Product Change Notification (PCN)

PCN #: 1B-2020

Laird Part Number	Old Rev	New Rev	Description
Temp & Humidity Sensors			
455-0001	9	11	Kit, Sentrius RS191 Sensor, Temp & Humidity, NA, 915MHz
455-0002	9	11	Kit, Sentrius RS186 Sensor, Temp & Humidity, EU, 868MHz
External Probe Sensors			
455-00069	2	4	Kit, Sentrius RS186 Sensor, External Temp Probe, EU, 868MHz
455-00070	2	4	Kit, Sentrius RS191 Sensor, External Temp Probe, NA, 915MHz

5.1 Top Level Part Number Changes (packaged kits)

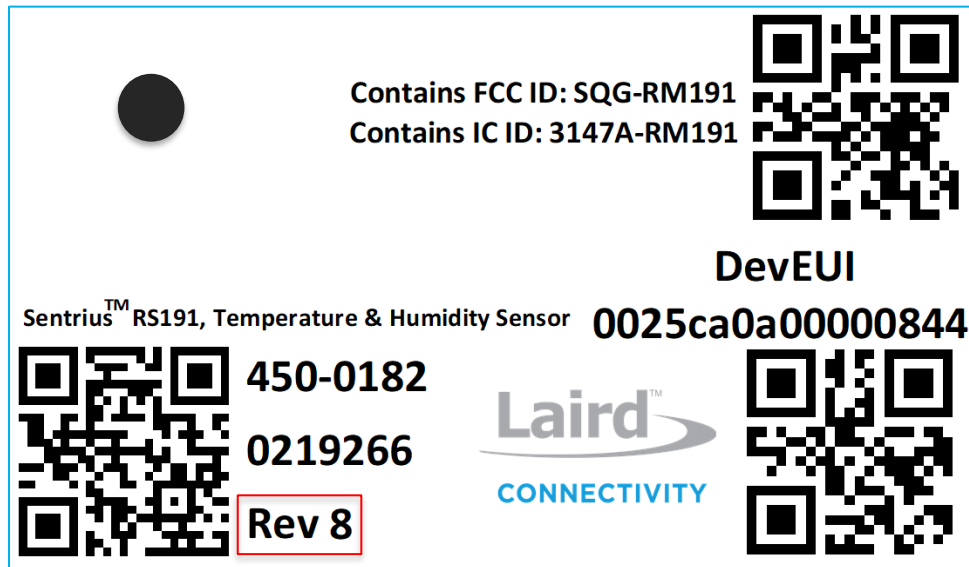
- In the situation where older revision 450-part numbers have been installed with the latest FW 6.0 revision in production, a black dot will be placed on the sensor back label to indicate this change. A duplicate label will be placed on the base of the kit label as well in the bottom right hand corner.

Associated kit part number and revision will be printed on the label within red square area.

Note: Label located on the bottom right corner of the kit base label contains the same label info as printed on the sensor contained within the specific kit (~~On Sensor Changes~~ **On Sensor Changes** section).

5.2 On Sensor Changes

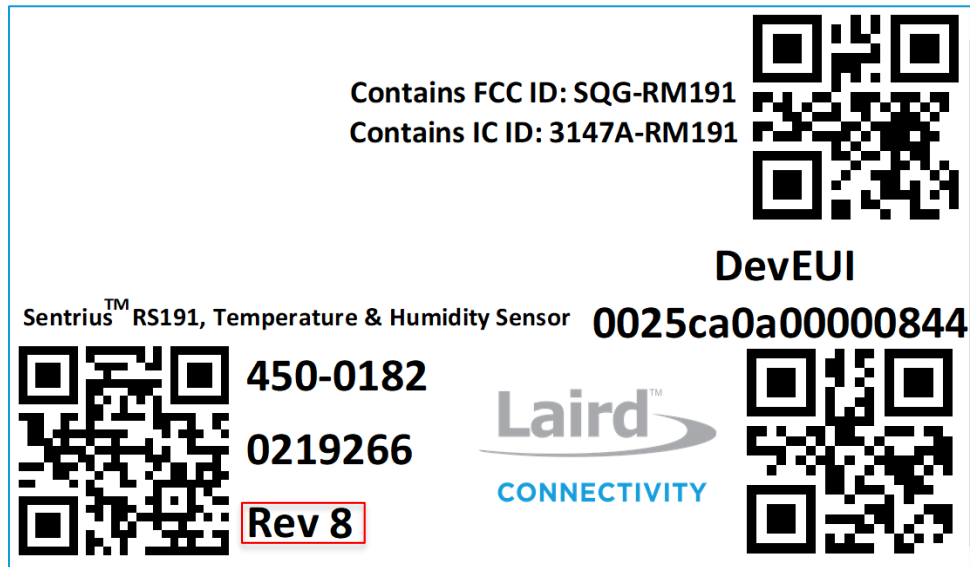
- Labelling Changes for Sensors with an older 450 assembly revision, a “black dot” will be placed on the back-sensor label – Revision change available as revision number printed by barcode and within barcode for all sensor back labels.

Note: Revision level shown for reference. The appropriate revision level will be printed on the label.
